SHEARON HARRIS NUCLEAR POWER PLANT
UNIT NO. 1 - DOCKET NO. 50-400
COMMENTS ON PROOF AND REVIEW TECHNICAL SPECIFICATIONS

Attachment I
Comments on Proof of Review TS

SHNPP Proof and Review Technical Specifications

Record Number: 146

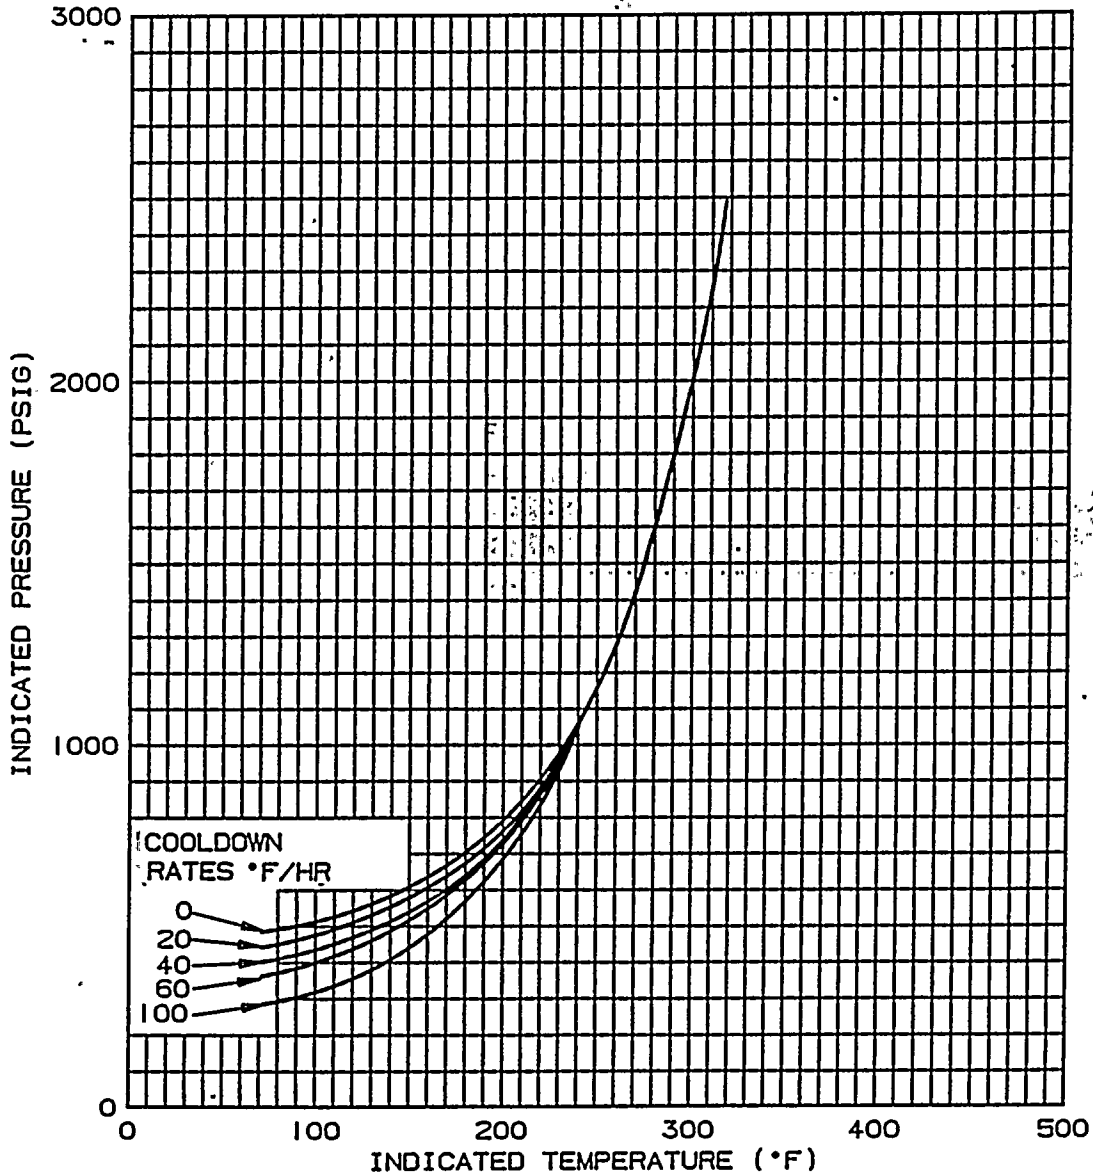
Section Number: FIGURE 3.4-2

IN THE TITLE FOR FIGURE 3.4-2 CHANGE THE WORD
"HEATUP" TO "COOLDOWN".

Basis

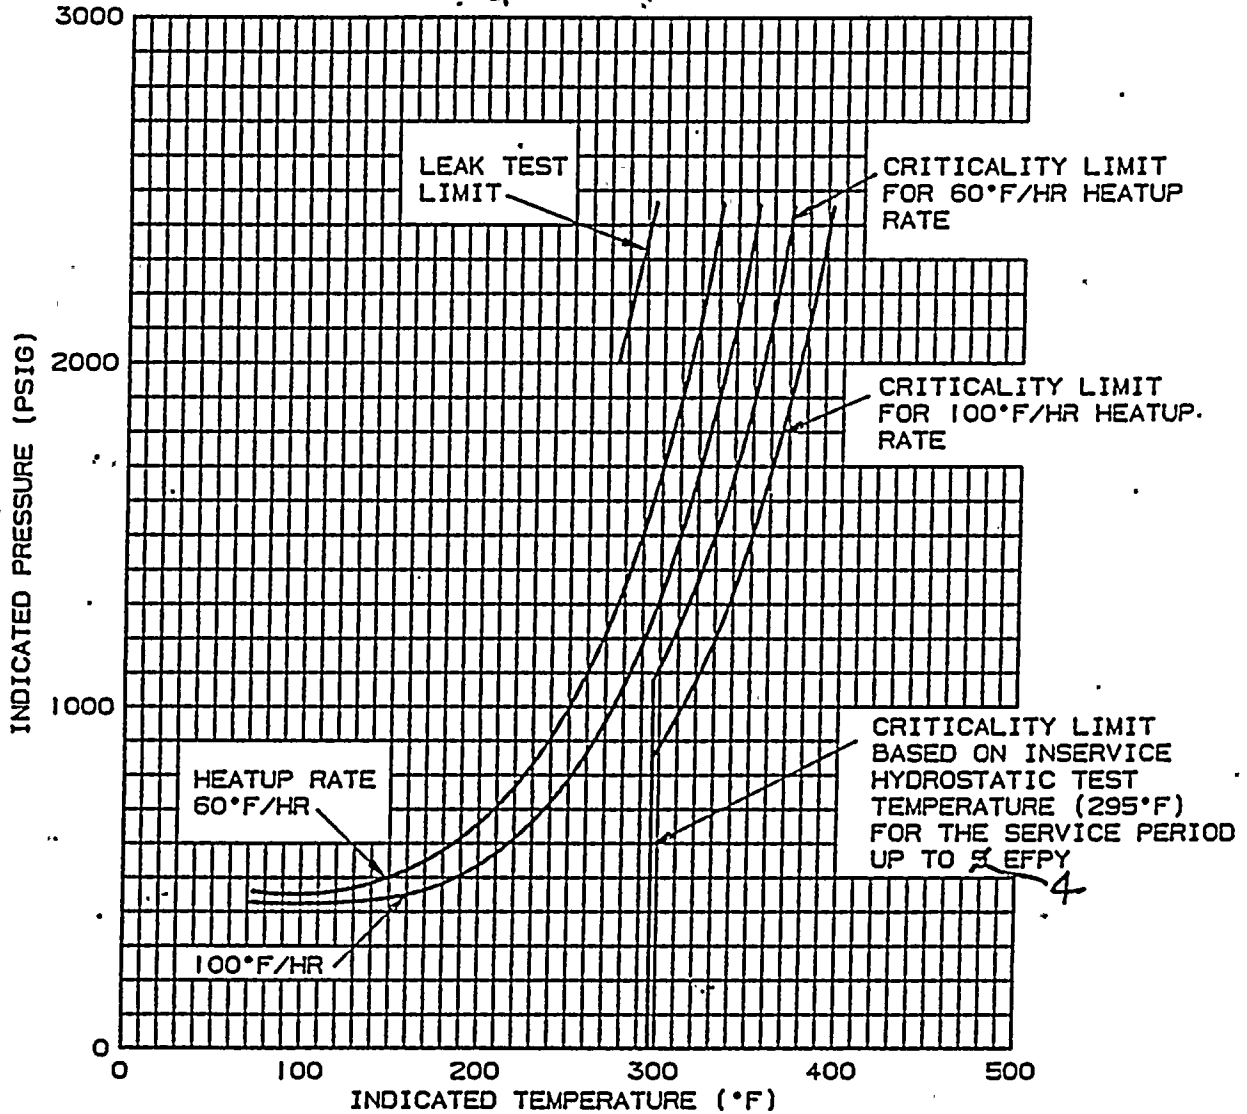
Section Number: FIGURE 3.4-3

IN THE TITLE FOR FIGURE 3.4-3, CHANGE THE WORD
"COOLDOWN" TO "HEATUP".

FIGURE B.3/4.4-1

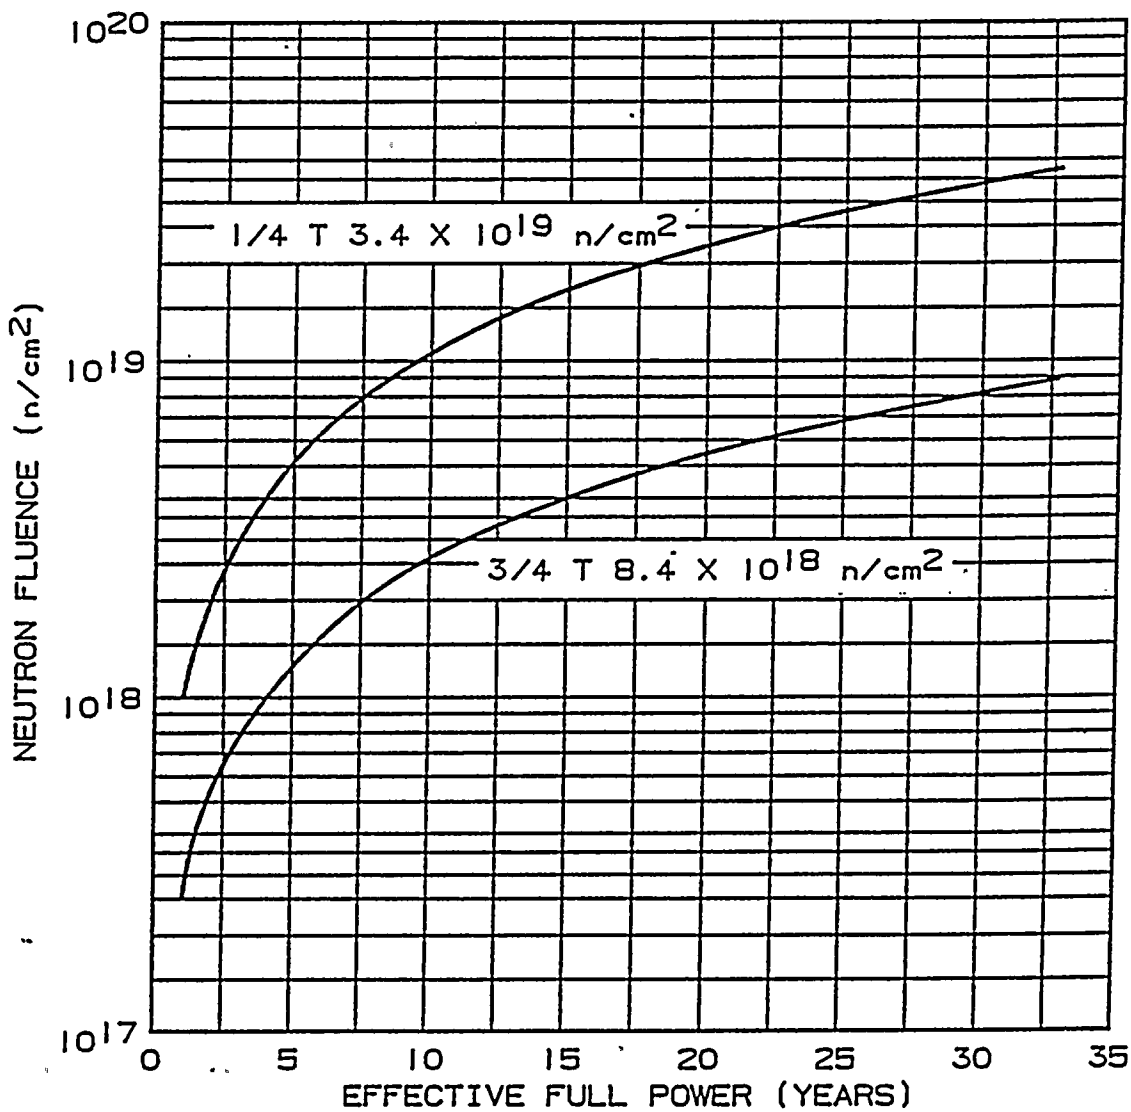
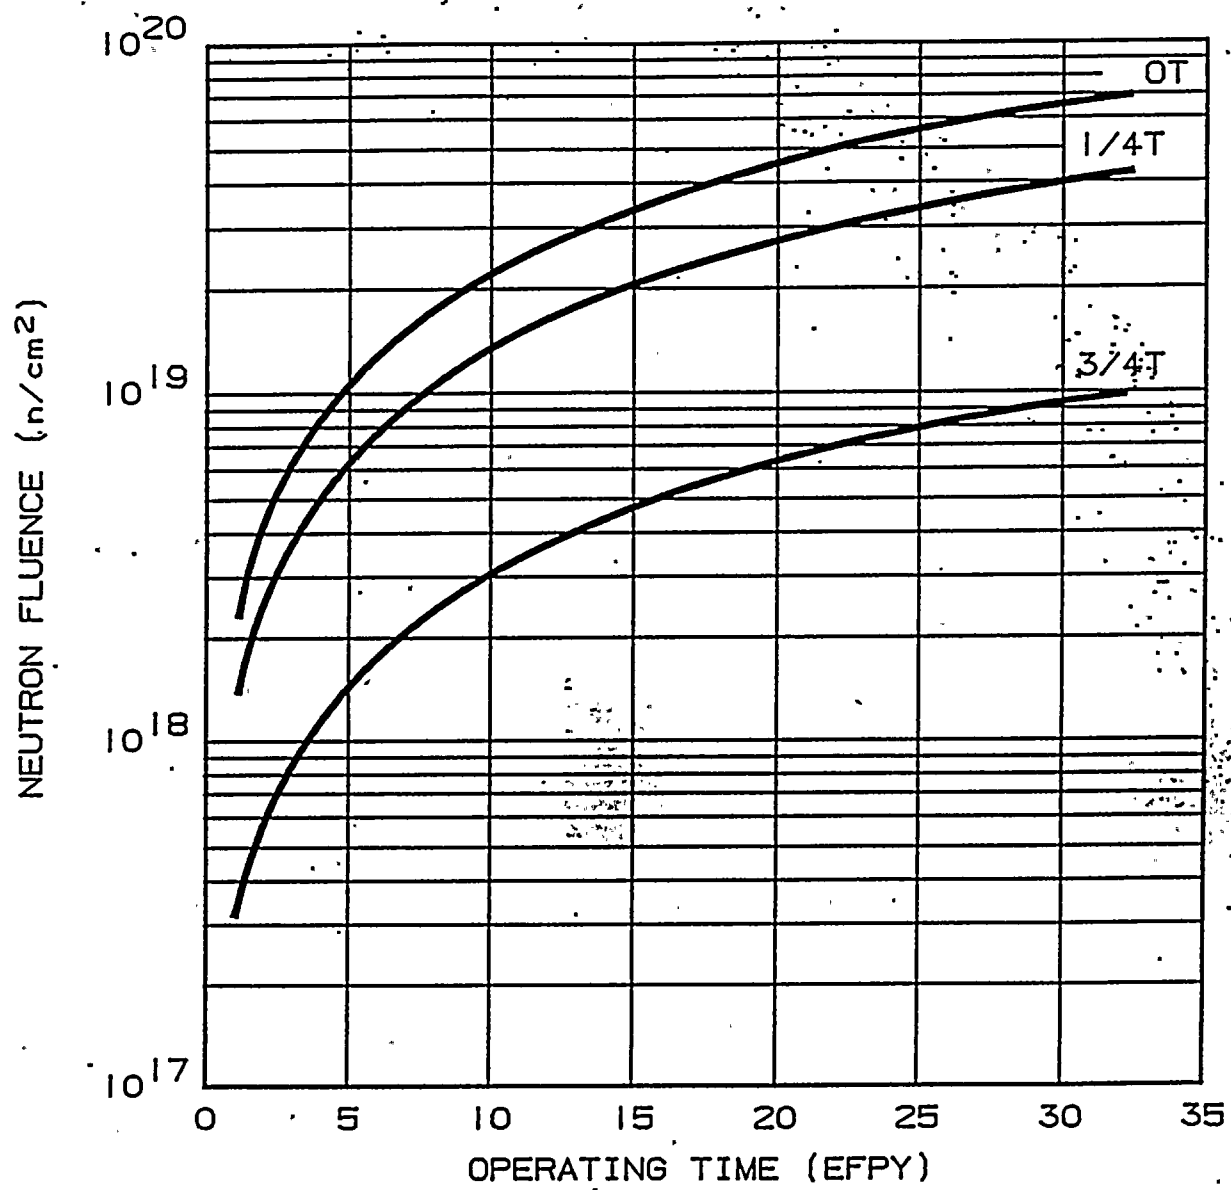
Section Number: FIGURE B3/4 4-1

REPLACE FIGURE B 3/4.4-1 WITH NEW FIGURE.
